PRODUCT SERVICE BULLETIN

No. 202

UNIT MODEL NUMBER:	All
UNIT SERIAL NUMBER:	All
COMPONENT AFFECTED:	Low Water Level Circuits
AFFECTED DATES:	3/01/01 - 8/01/01
REASON FOR NOTIFICATION:	Potential for premature low water level fault on units equipped with the Low Water Level Board, Part Number 74063, shipped during the affected dates mentioned above.

INSTALLATION DIAGRAM

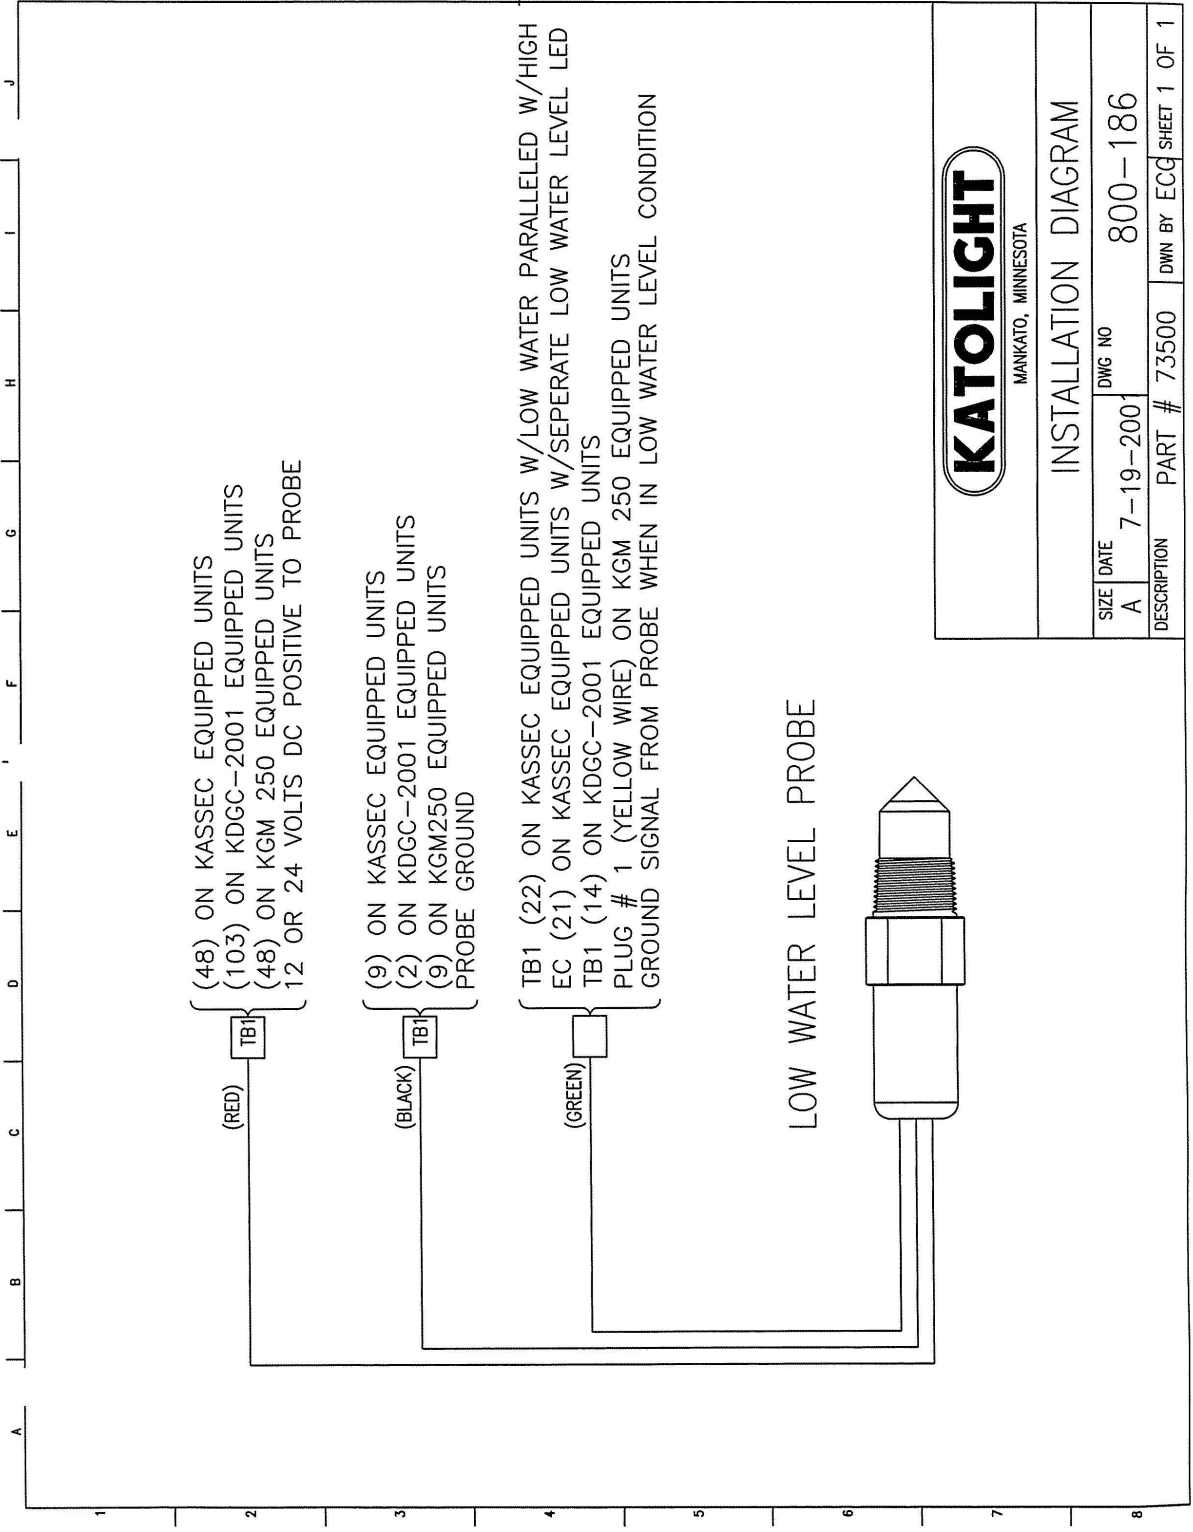
5. Make the electrical connections to the new probe as shown on the attached drawing, the existing shielded wire will be used for the positive (red wire) and signal (green wire) connections, the ground (black wire) will require adding another wire to go to a ground point on the engine block.

6. The control panel harness will need to have the following modifications made. Shield the #11 (white) will move from TB1-11 to TB1-22, the shield wire #9 will move from TB1-9 to TB1-48 and the wires should be renumbered to match. On the most recent models all wiring changes have been made and will only require the installation of the probe with connection to the harness.
